Packet Related Material

Ord 04-09 To Amend the Bloomington Zoning Maps from RS 3.5/PRO6 To PUD and to Amend the Preliminary Plan for the Renwick Planned Unit Development (PUD) - Re: 2410 East Moores Pike (Ramsey Land Development, Petitioner)

Interdepartmental Memo

TO: City of Bloomington Plan Commission
FROM: Environmental Commission
LIAISON: Linda Thompson, Senior Environmental Planner
DATE: April 7, 2004
SUBJECT: PUD-53-03 Renwick

Exhibit A
Revisions for Environmental
Protection

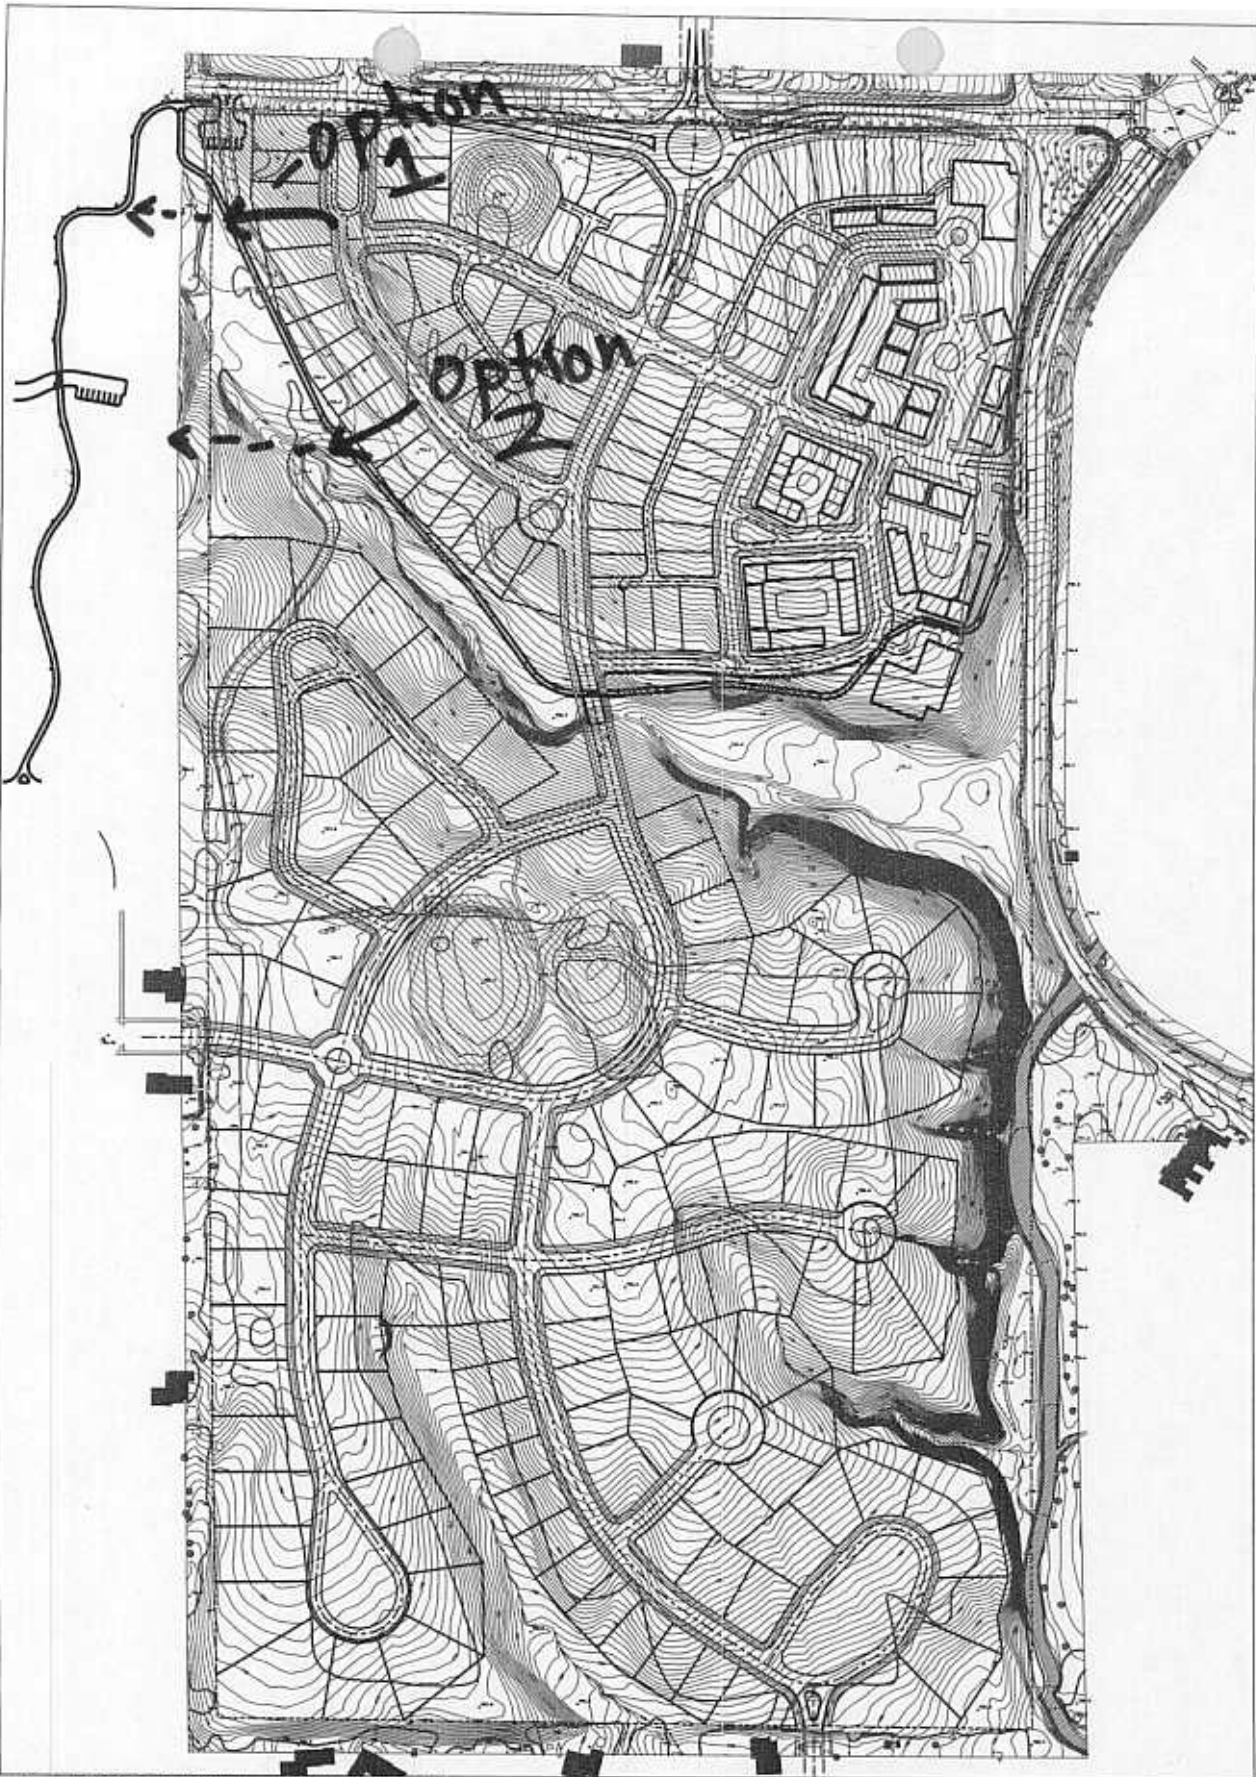
In response to input from staff as well as the Planning Subcommittee of the Environmental Commission, the petitioners committed to additional restrictions designed to address steep slope protection, tree preservation, and greater sinkhole buffering. These modifications were as follows: (see Exhibit A in the packet material):

Exhibit B
Additional Staff Recommended Revisions

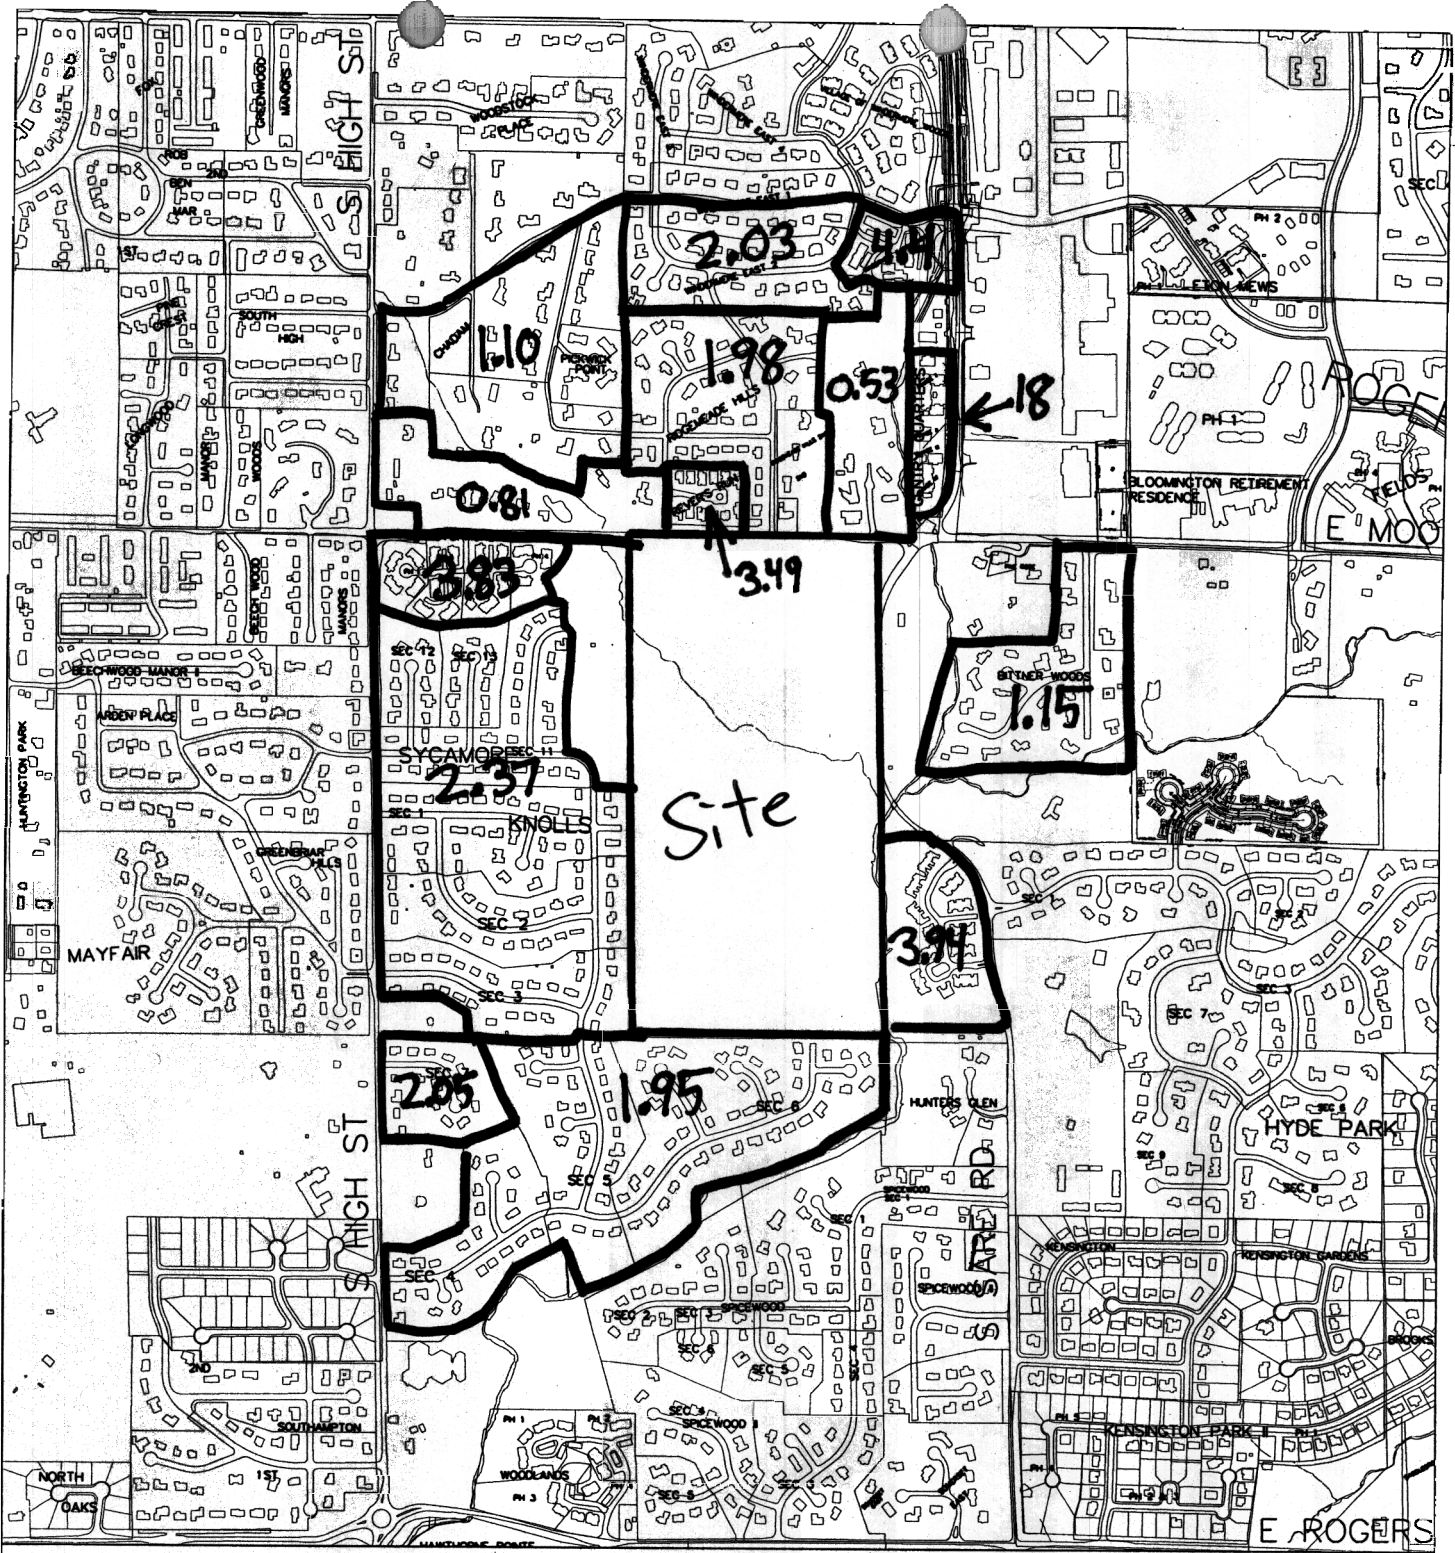
Issue #1 – Environmental Protection – As discussed previously in this memo, the petitioners made significant changes to the preliminary plan to respond to staff recommendations regarding tree stand preservation, sinkhole buffer protection, steep slope protection, and preservation of existing drainageways. Exhibit B depicts areas of the petitioner’s preliminary plan where no preservation agreement had yet been reached. In the case of two of the proposed lots outlined in this exhibit, staff asserted that there was adequately dense, albeit immature tree cover that warranted inclusion into the petitioner’s conservation area. In the case of the final lot, the petitioner had not yet demonstrated that an existing drainage swale could be adequately protected through the utilization of appropriate natural vegetative buffering. Staff recommended that the Plan Commission require modifications to the preliminary plan as dictated in Exhibit B.

Resolution: Rather than attempt to resolve these final environmental issues at a conceptual plan stage, the Commission opted to wait until final plan review. This resolution was incorporated into a revision to Condition of Approval #3.

3. Future final plans shall consider the Planning Department's proposed conservancy areas as recommended in Exhibit B.
4. The petitioner's proposed Village Center shall be limited by the restrictions outlined in the revised petitioner's statement, and with the additional definition of Business Service indicated in the staff report.

JOB TITLE
RENWICK DEVELOPMENT
SARE ROAD & MOORE'S PIKE
INTERSECTION

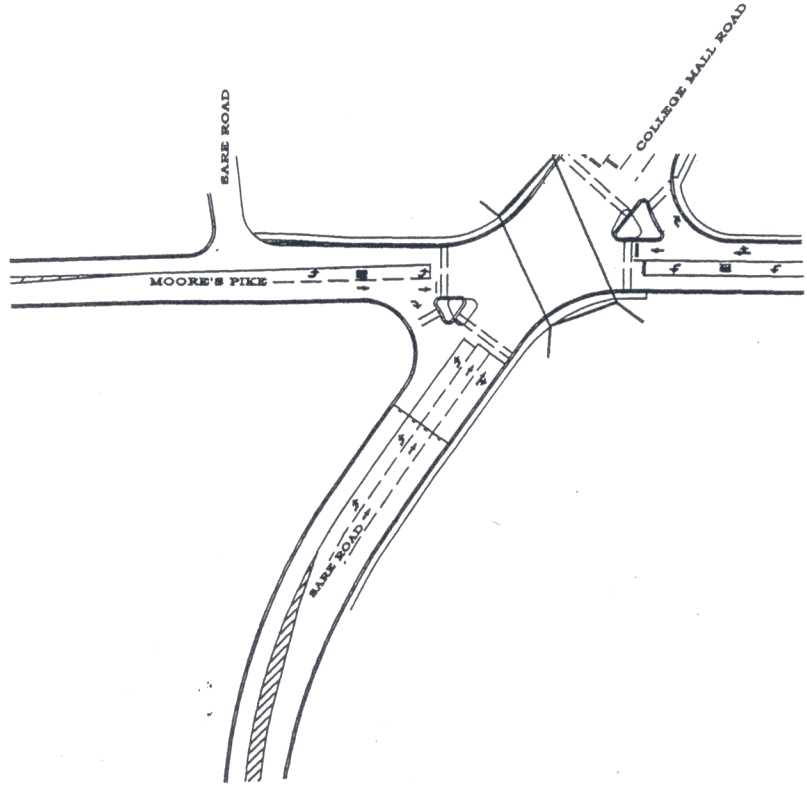
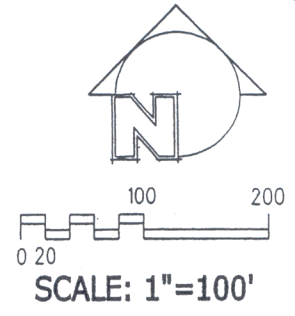
- The Sare Rd/Moores Pike intersection drops from its existing LOS C to LOS E during the AM peak hour and from its current LOS B to LOS C in the PM peak hour. Intersection improvements should be considered.
- The High Street/Moores Pike intersection operates at LOS C before and after development.
- The Sare Road intersection with Renwick should provide separate lanes for left turn movements.
- Traffic on Moores Pike must be interrupted for Renwick Traffic. A roundabout is recommended.
